APPLICATION NO.	FILING DATE	FIRST NAMED INVENTOR	ATTORNEY DOCKET NO.	CONFIRMATION NO.
10/540,785	06/27/2005	Atsushi Miyake	SUGI-102US	2095
23122	7590	11/23/2007	EXAMINER	
RATNERPRESTIA			COOK, JONATHON	
P O BOX 980			ART UNIT	PAPER NUMBER
VALLEY FORGE, PA 19482-0980			2886	
			MAIL DATE	DELIVERY MODE
			11/23/2007	PAPER

Office Action Summary	Application No. 10/540,785	Applicant(s) MIYAKE ET AL.	
	Examiner Jonathon D. Cook	Art Unit 2886

Detailed Action

(modified figure 2)

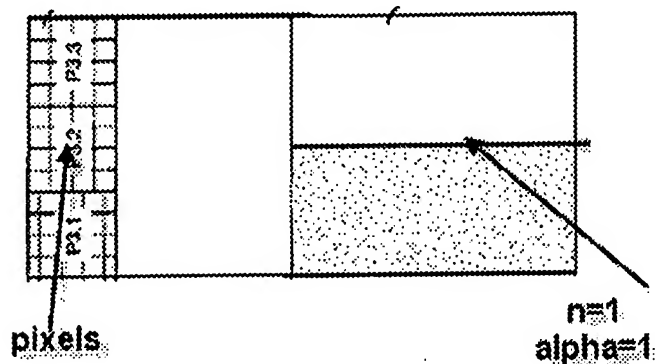
First the equation $4 \pm \alpha/4$ is not in the claims. The examiner is not even sure of the relevance of this equation. Applicant claims $Xn \pm \alpha$, where $X=4P$ (P being an integer greater than 0), n = the number of grids, and α is the number of fringes. As can be seen in the modified figure 2 below, $\alpha=1$ & $n=1$. Therefore, $Xn \pm \alpha=3$ or 5 (when $P=1$). As can be seen there fore 3 pixels shown therefore this figure clearly shows Pingel meeting this part of the limitation.

Next, applicant argues because α is greater than 0, then n and $Xn \pm \alpha$ cannot be multiples of one another. However, as shown above $Xn \pm \alpha=3$ & $n=1$ when $\alpha=1$. 1 and 3 are multiples of each other therefore the limitation does hold true. If you were to extrapolate that for the case of $n=2$, then you get $\alpha=2$, & $Xn \pm \alpha=6$ and the limitation is still met.

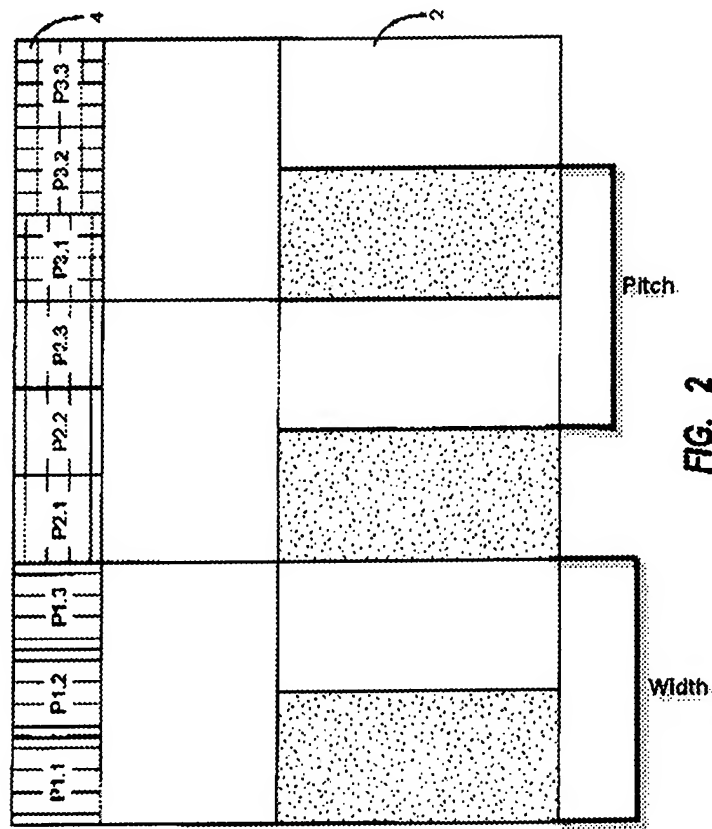
a step of picking-up an image of a grid pattern having an array having a bright portion and a dark portion with a constant pitch and a constant width (see modified figure 2 below) by using an image pickup device including a CCD pixel array and enabling $Xn \pm \alpha$ CCD pixels to correspond to n grids, where X is an integer which satisfies the equation $X=4P$, P being an integer greater than zero, and n and α are integers greater than zero, thereby generating α moiré fringes, upon picking-up the image of the grid pattern on said image pickup device,

The moire image which is detected on the camera results from superimposition of two brightness distributions with a specific periodicity, in which case the approximate profiling of sinewave of the moire structure can be recognized on the "grid" of pixels

over the width of a line pair of the sequence which corresponds to a light/dark period

in the above illustration three pixels correspond to one pair of dark and light areas. In the applicant's disclosure $X = 4p$ ($p = 1$ or more), in the above illustration each dark and light pair would produce one moire fringe so $\alpha = 1$, therefore if $p = 1$ the limitation is met;
